Access Compliance Report

Public Rights-of-Way

(Curb Ramps)

Intersection ID: 52487	Main Street: WHITEHALL_EXECUTIVE_CENTER_DR	Cross Street: ORLICK_DR	Location: N
ADA ID: EAFB243EC9BB	Ramp Type: Perp	Initial Pass/Fail: Fail	Overall Compliance: No
Severity Score: 13.75			
Codes/Mitigation Info/Possible Solution		Field Measurements/Component Compliance

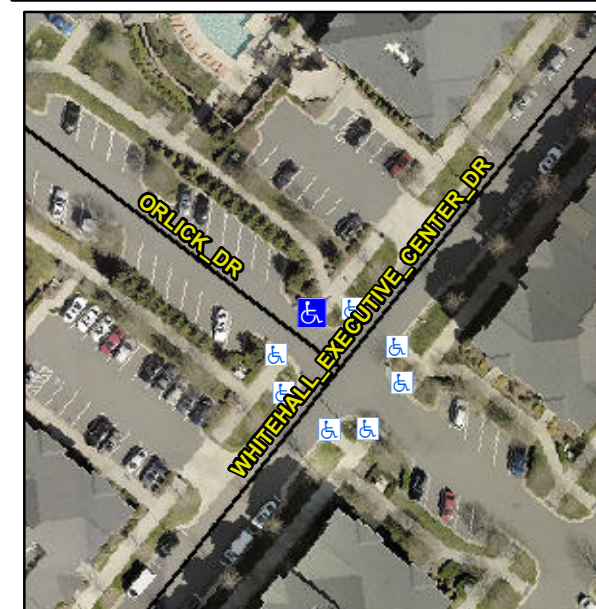
Not Found, R304.2.2, R304.5.3

Compliance	Description	Data	Compliance	Description	Data
N/A	Ramp Length (in)	111.0	No	Ramp Slope (%)	8.6
Yes	Ramp Width (in)	95.0	No	Ramp XSlope (%)	2.3
N/A	Flare Type LT	N/A	N/A	Flare Type RT	N/A
N/A	Flare Slope LT (%)	N/A	N/A	Flare Slope RT (%)	N/A
N/A	Flare Traversable LT?	N/A	N/A	Flare Traversable RT?	N/A
N/A	Landing Length (in)	N/A	N/A	DWS Provided?	N/A
N/A	Landing Width (in)	N/A	N/A	DWS Contrast?	N/A
N/A	Landing Slope (%)	N/A	N/A	DWS Length (in)	N/A
N/A	Landing X Slope (%)	N/A	N/A	DWS Full Width?	N/A
N/A	Landing Curb? (Y/N)	N/A	N/A	DWS Offset (in)	N/A
N/A	Shared Landing?	N/A			
N/A	Gutter Ponding?	N/A	N/A	Gutter Slope (%)	N/A
N/A	Gutter Lip Ht (in)	N/A	N/A	Gutter X Slope (%)	N/A
N/A	Painted X Walk1?	No	N/A	Painted X Walk2?	N/A
	X Walk 1 Direction	To SW		X Walk 2 Direction	N/A
N/A	X Walk 1 Width (in)	N/A	N/A	X Walk 2 Width (in)	N/A
	X Walk 1 Slope (%)	0.8		X Walk 2 Slope (%)	N/A
	X Walk 1 X Slope (%)	1.9		X Walk 2 X Slope (%)	N/A

Remove & Replace Entire Ramp.
